Access Compliance Report

Public Rights-of-Way

(Curb Ramps)

Intersection ID: 49348	Main Street: HONEY_FIG_RD	Cross Street: FIRESPIKE_RD	Location: SE
ADA ID: 195243FE5227	Ramp Type: Perp	Initial Pass/Fail: Fail	Overall Compliance: No
Severity Score: 22.5			
Codes/Mitigation Info/Possible Solution		Field Measurements/Component Compliance

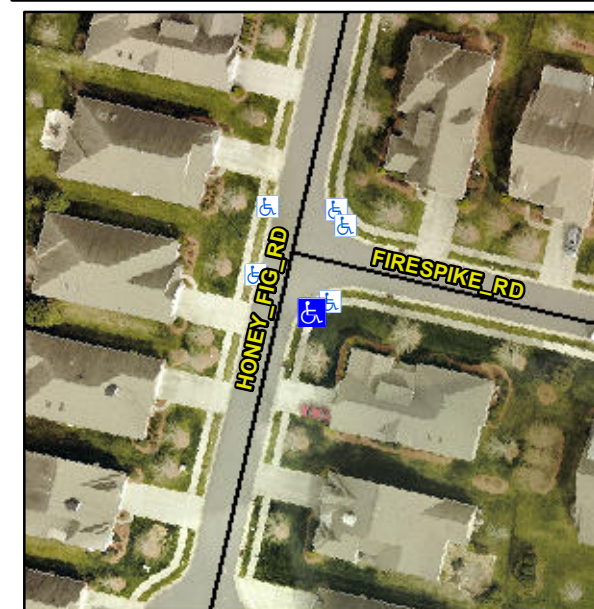
Not Found, R304.5.1, R304.2.2, R304.5.3

Compliance	Description	Data	Compliance	Description	Data
N/A	Ramp Length (in)	48.0	No	Ramp Slope (%)	8.4
No	Ramp Width (in)	47.0	No	Ramp XSlope (%)	2.6
N/A	Flare Type LT	N/A	N/A	Flare Type RT	N/A
N/A	Flare Slope LT (%)	N/A	N/A	Flare Slope RT (%)	N/A
N/A	Flare Traversable LT?	N/A	N/A	Flare Traversable RT?	N/A
N/A	Landing Length (in)	N/A	N/A	DWS Provided?	N/A
N/A	Landing Width (in)	N/A	N/A	DWS Contrast?	N/A
N/A	Landing Slope (%)	N/A	N/A	DWS Length (in)	N/A
N/A	Landing X Slope (%)	N/A	N/A	DWS Full Width?	N/A
N/A	Landing Curb? (Y/N)	N/A	N/A	DWS Offset (in)	N/A
N/A	Shared Landing?	N/A			
N/A	Gutter Ponding?	N/A	N/A	Gutter Slope (%)	N/A
N/A	Gutter Lip Ht (in)	N/A	N/A	Gutter X Slope (%)	N/A
N/A	Painted X Walk1?	No	N/A	Painted X Walk2?	N/A
	X Walk 1 Direction	To NW		X Walk 2 Direction	N/A
N/A	X Walk 1 Width (in)	N/A	N/A	X Walk 2 Width (in)	N/A
	X Walk 1 Slope (%)	2.4		X Walk 2 Slope (%)	N/A
	X Walk 1 X Slope (%)	1.4		X Walk 2 X Slope (%)	N/A

Remove & Replace Entire Ramp.
